Access Compliance Report

Public Rights-of-Way

Intersection ID: 47854	Main Street: ADOBE_RD	Cross Street: CACTUS_VALLEY_RD	Location: NW
ADA ID: 9EC822D48940	Ramp Type: PerpDiag	Initial Pass/Fail: Fail	Overall Compliance: No
		Severity Score: 8.75

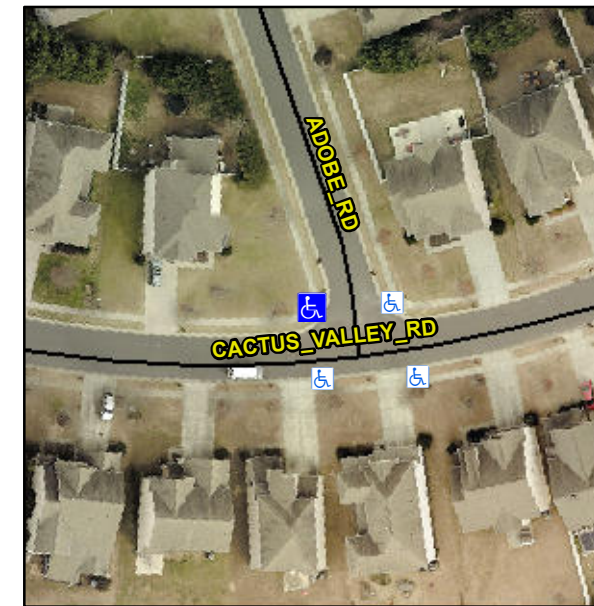
Not Found, R304.5.1

Compliance	Description	Data	Compliance	Description	Data
N/A	Ramp Length (in)	47.0	Yes	Ramp Slope (%)	5.9
No	Ramp Width (in)	47.0	Yes	Ramp XSlope (%)	0.9
N/A	Flare Type LT	N/A	N/A	Flare Type RT	N/A
N/A	Flare Slope LT (%)	N/A	N/A	Flare Slope RT (%)	N/A
N/A	Flare Traversable LT?	N/A	N/A	Flare Traversable RT?	N/A
N/A	Landing Length (in)	N/A	N/A	DWS Provided?	N/A
N/A	Landing Width (in)	N/A	N/A	DWS Contrast?	N/A
N/A	Landing Slope (%)	N/A	N/A	DWS Length (in)	N/A
N/A	Landing X Slope (%)	N/A	N/A	DWS Full Width?	N/A
N/A	Landing Curb? (Y/N)	N/A	N/A	DWS Offset (in)	N/A
N/A	Shared Landing?	N/A			
N/A	Gutter Ponding?	N/A	N/A	Gutter Slope (%)	N/A
N/A	Gutter Lip Ht (in)	N/A	N/A	Gutter X Slope (%)	N/A
N/A	Painted X Walk1?	No	N/A	Painted X Walk2?	No
	X Walk 1 Direction	To S		X Walk 2 Direction	To E
N/A	X Walk 1 Width (in)	N/A	N/A	X Walk 2 Width (in)	N/A
	X Walk 1 Slope (%)	0.1		X Walk 2 Slope (%)	1.5
	X Walk 1 X Slope (%)	1.1		X Walk 2 X Slope (%)	0.2

Remove & Replace Curb Ramp With Two New Directional Ramps or Equivalent.
